# FIELD SERVICE BULLETIN

FSB 917

## Chameleon Headboard RECOM DC-DC Convertor Issue

**PRODUCT** Chameleon Ultra, Vision and Vision-S

Fig 1

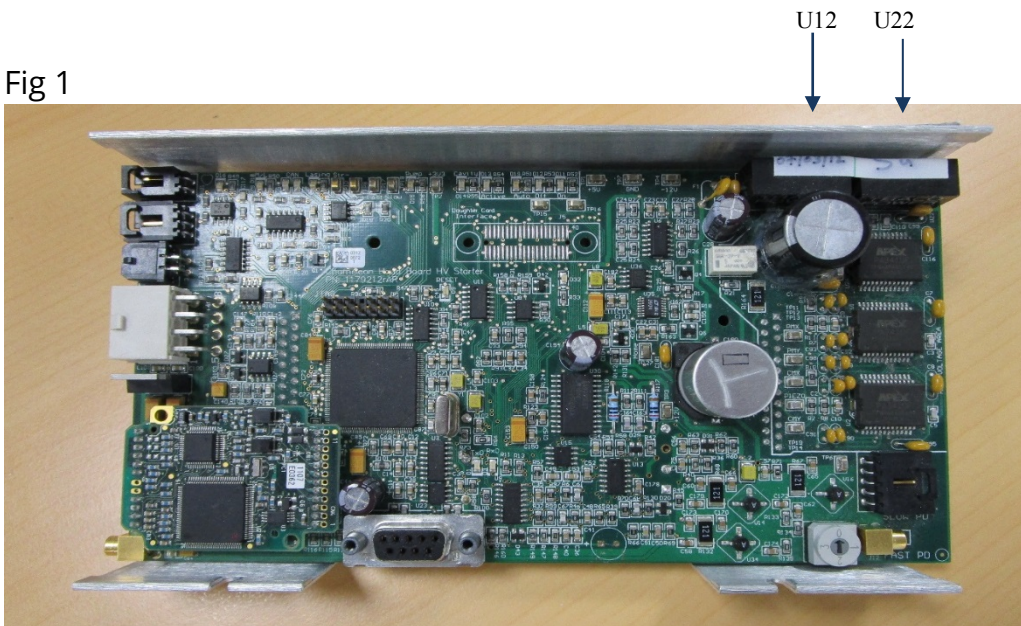
The location of U12 and U22 DC-DC convertors are shown in Fig 1. Fig 2 shows the TRACO type and Fig 3 shows the RECOM type.

For Chameleon laser systems which exhibit any of the [‘typical failure symptoms’](#) verify the DC-DC convertor type on the Chameleon headboard before making the decision to swap the laser. If the type is [RECOM](#) replace the Chameleon headboard. If the type is [TRACO](#), then continue with trouble shooting, bearing in mind that there may still be an issue with the Chameleon headboard.

Fig 3

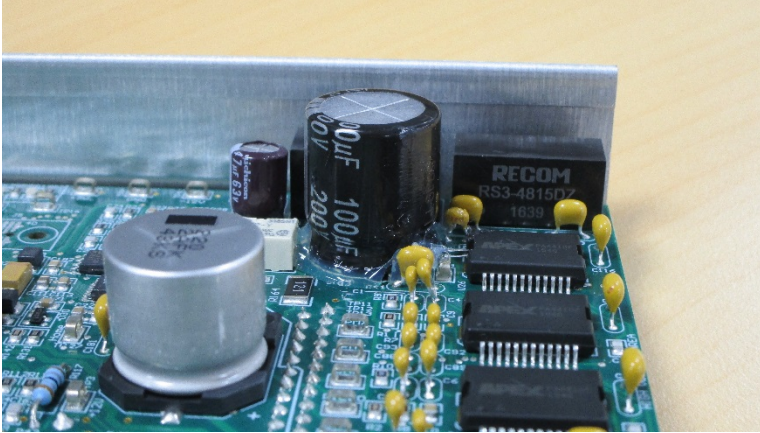
**DESCRIPTION** The DC-DC converter found on the Chameleon headboard can either be one of the following types RECOM or TRACO. During in-house failure analysis we have found that the RECOM version operates at a higher temperature and the part itself can get hot over time, potentially causing failure in the headboard circuitry. The TRACO version does not exhibit this issue.

U12 and U22

Type: **RECOM**

**REPLACE HEADBOARD**
